**Re: Response to EPA Analysis of the *Final Habitat Mitigation and Monitoring Plan*, dated September 12, 2017, EPA Comments October 5, 2017 (Revised November 30, 2017)
Rosemont Copper Project, Clean Water Act Section 404 Permit, CoE File No.: 2008-00816-MB**

**RESPONSE TO ENVIRONMENTAL
PROTECTION AGENCY (2017)**

**"The Mitigation Proposed by Rosemont Mine
Will Not Offset Impacts to Waters of the U.S.
below the Level of Significant Degradation"**

Project Number: 1049.117
January 24, 2018

Figure 16. Bank and Buffer Rehabilitation at Lower Sonoita Creek

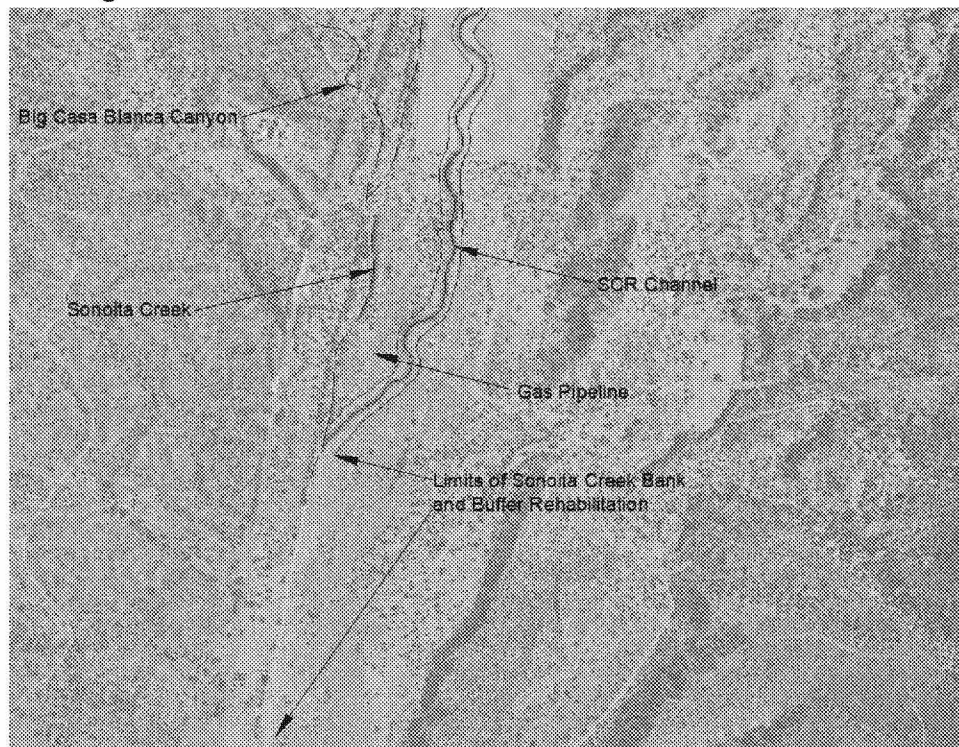
The EPA (2017) discourages the SCR mitigation project component that includes bank and buffer rehabilitation along the eastern bank of a reach downstream of the major channel rehabilitation reaches. The letter discounts channel bank sloughing and erosion as normal conditions and suggests that Sonoita Creek's channel banks be allowed to erode towards an equilibrium state characterized by a high-functioning floodplain.

This comment is notable in that it directly contradicts the EPA's comment in the immediate preceding paragraph, wherein they recommend rehabilitation along the eastern bank of the existing Sonoita Creek. Bank and buffer rehabilitation along the eastern bank is not practical for Sonoita Creek throughout the majority of SCR because there is not enough space between Sonoita Creek and the gas pipeline. However, bank and buffer rehabilitation is feasible along lower Sonoita Creek (as opposed to backfilling and replacing Sonoita Creek) because there is sufficient space, generally 330 to 350 feet, between lower Sonoita Creek and the gas pipeline (**Figure 16**).

Figure 17. Effect of Elevated Roadway on Tributary Flowpaths

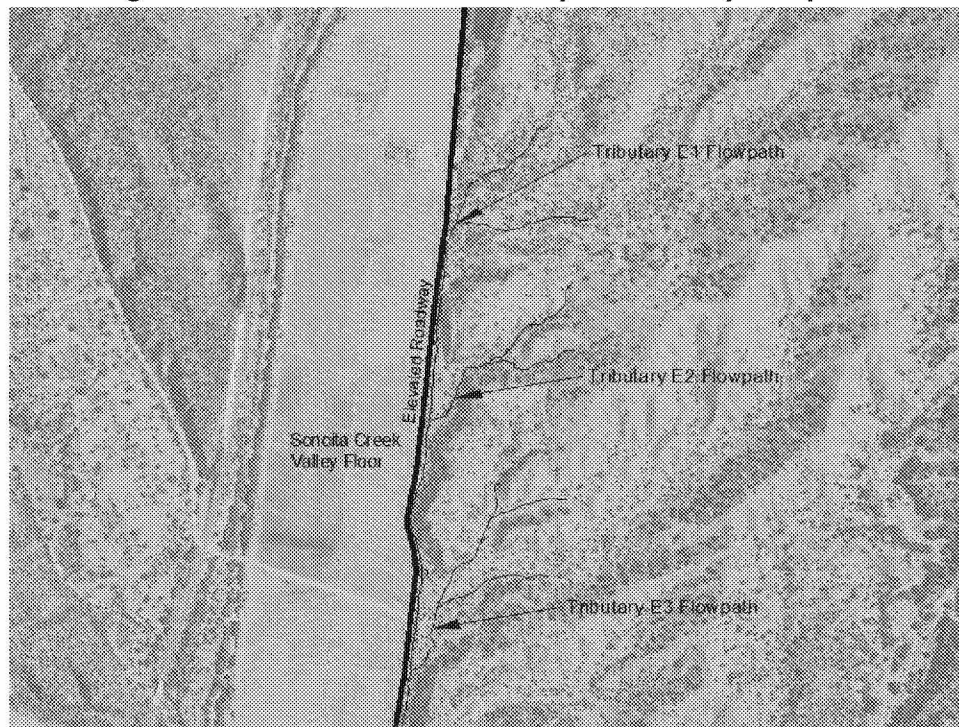
The EPA (2017) further asserts that the access road on the eastern edge of the agriculture field does not block the flows from the three tributaries. In response, we note that the access road was constructed as a linear fill across the eastern valley edge that is generally 4 to 5 feet higher than the existing terrain to the east. There are no culverts to convey discharge from the eastern tributaries under the road into the Sonoita Creek valley. The access road clearly interrupts flow and sediments from the three tributary channels based upon observations during field investigations (**Figure 17**). Sonoita Creek at SCR is a valley fill that was created as a result of sediments from the tributary watersheds being conveyed into and deposited on the valley floor. The HMMP proposal to reconnect the three eastern tributaries to the SCR Channel will reestablish natural continuity for stormwater hydrology and sediment transport into the Sonoita Creek valley. Furthermore, reestablishment of even small ephemeral drainages such as these will result in a more diverse and natural ecological condition. Therefore, reconnecting the three tributaries will provide substantial ecological benefit for the eastern side of the valley in that area.

The EPA (2017) finally states that there is not sufficient stream power to form a permanent bed and bank channel for the three tributaries. A defined bed is already observed where the roadway interrupts natural flow and diverts stormwater south along the road fill, and there are defined beds for each tributary upstream of the area where they currently terminate. It is speculative to suggest that the channel bed and bank features of the three reestablished connections to Sonoita Creek will recede over the long-term. Even if they do, eliminating the elevated roadway will reestablish the natural drainage pattern for stormwater and sediment to enter the Sonoita Creek valley with associated ecological benefits.

Exhibit 5. Average-Annual Runoff Regression from Stone et al. (2008)

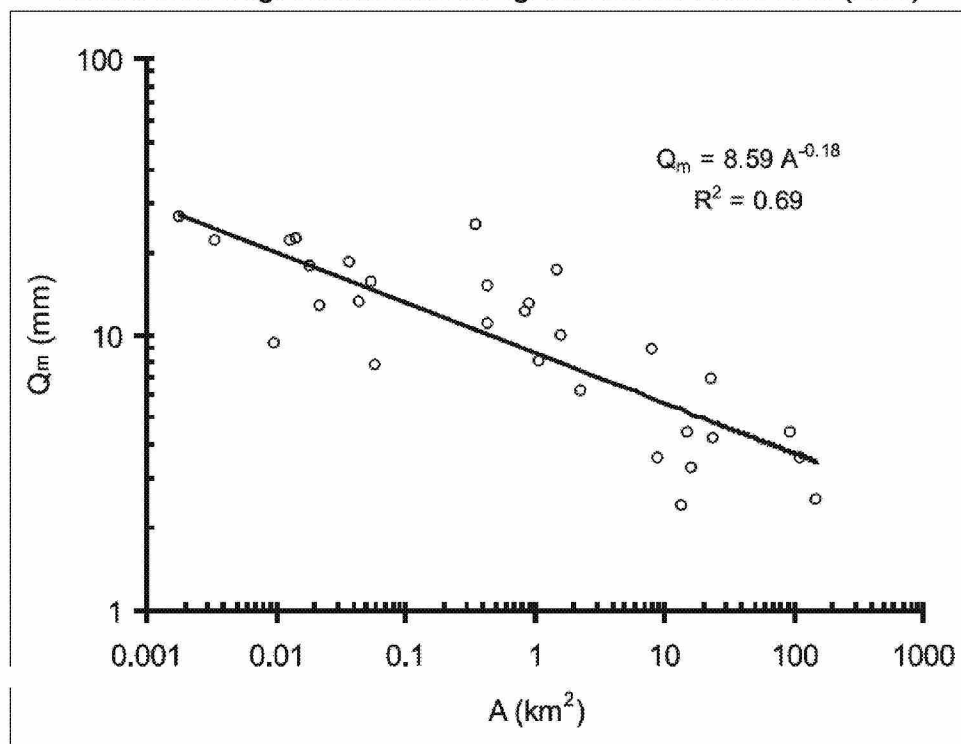
The EPA (2017) has expressed concern relating to the revised pre-mining and post-mining estimates and has questioned the validity of the methodology: “*The estimates of average-annual runoff rely on an inappropriate model/regression equation. The regression equation can only apply to the limits of the data. A continuous simulation model with daily time steps would be more appropriate. A regional model such as a SWAT-based model that is localized with smaller resolution grids is an example of such an approach.*” This observation is flawed, however, because it is not the resolution or time step of the model that is of primary importance, but rather the relative comparison between the modeling results (i.e., modeled pre-mining flows vs. modeled post-mining flows). The EPA’s assertion, that a continuous simulation model with daily time steps is

The EPA (2017) also comments that the runoff regression methodology used does not consider stock pond capacities, and that if pond capacities are taken into account, the runoff regression methodology will demonstrate that the ponds do not have sufficient capacity. The EPA is correct, in that the stock ponds will not have sufficient capacity to retain runoff volumes estimated by the runoff regression methodology. However, it has recently become apparent, based on nine years of continuously recorded streamgauge data at the USGS gaging station located immediately downstream of the Rosemont watershed in Barrel Canyon at SR 83 (USGS 09484580 BARREL CANYON NEAR SONOITA, AZ; referred to herein after as the USGS SR 83 streamgauge), that the runoff regression methodology originally employed to estimate average-annual runoff is, in fact, extremely conservative, and significantly overestimates runoff volumes emanating from the Project watershed area. That is, recent runoff data, recorded for the past 9 years (from 2009 through December 31, 2017) at the USGS SR 83 streamgauge indicates that the average-annual runoff (on a calendar-year basis) is approximately 124.4 AFA. The minimum value recorded was 34.0 AFA (in 2009), and the maximum value recorded was 260.8 AFA (in 2017; includes provisional data). Thus, the regression methodology significantly overestimates actual annual runoff measurements by more than 11 times ($11.3 = 1,404 \text{ AFA} / 124.4 \text{ AFA}$). Given the lack of data from this streamgauge at the time the original regression equations were developed in 2010, it was necessary to use data from regional USGS-gaged watersheds. As such, the original regression equation analyses significantly overestimated the amount of flow discharging from the Rosemont watershed.

However, before such a demonstration is presented, the following additional information is provided regarding the actual runoff that discharges from the Rosemont watershed. In 2008, Stone et al. (2008) collected and analyzed average-annual runoff volumes that were collected from streamgages on the Walnut Gulch and the Santa Rita Experimental watersheds, both located in southern Arizona and in close proximity to the Rosemont watershed. Using the runoff data, which was collected as early as the 1950s, Stone et al. (2008) developed a regression equation to estimate average-annual runoff based on watershed area. This equation is presented in **Exhibit 5** and compares average-annual stormwater runoff per unit area to the size of the catchment area.

Note: The equation depicted in the preceding figure for average-annual runoff per unit area is: $Q_m = 8.59A^{-0.18}$, where the units of runoff (Q_m) are average depth in millimeters per unit area (square kilometer), and the units of area (A) are in square kilometers.

Exhibit 6. Three (3) Year Total Annual Precipitation Variability across the Rosemont Project Watershed

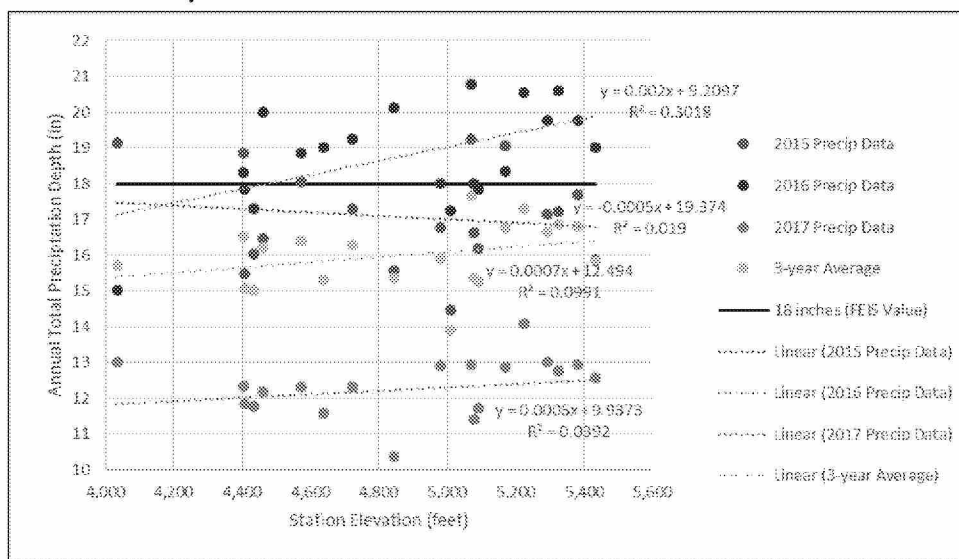
The EPA (2017) also provides the following comment with regard to precipitation across the site: *“The model parameterization for average annual rainfall (i.e., 18 inches) in Equation 2 is likely significantly less than values at the higher-elevation stock pond locations.”* Here, the EPA is alluding to a presumed relationship between elevation and precipitation at the Rosemont Project, where higher elevation theoretically equates to higher precipitation. While that orographic relationship may exist on a regional scale, it is less evident on a smaller watershed scale, such as for the Rosemont Project where the watershed is a maximum of 5.5 miles wide (measured from the southwest corner of Wasp Canyon sub-watershed to the USGS SR 83 streamgage).

Exhibit 6 shows the total annual rainfall (recorded at each of the 21 gages) plotted against the gage elevation. Best fit linear regression trend lines (and equations) are also plotted. Although there are only three years of data available (from May 2015 through December 2017), four important conclusions can be made: (1) there is a high year-to-year variability in total annual precipitation (e.g., in 2016 the total average precipitation throughout the site was about 18.8 inches, but only 12.2 inches in 2017); (2) there does not appear to be any meaningful relationship showing an increase in total annual precipitation with elevation (e.g., R^2 values are all less than 0.3, which indicate that the linear regression equations do not

represent any meaningful relationship); (3) there is high variability in total annual precipitation across the watershed (e.g., in several cases, gages at lower elevations had higher precipitation values than gages at higher elevations); and (4) the average value of 18 inches (used in the FEIS) is representative, and likely a conservative estimate, for the site-wide average. Thus, the average-annual rainfall value of 18 inches is valid and representative for the entire Rosemont Project watershed.
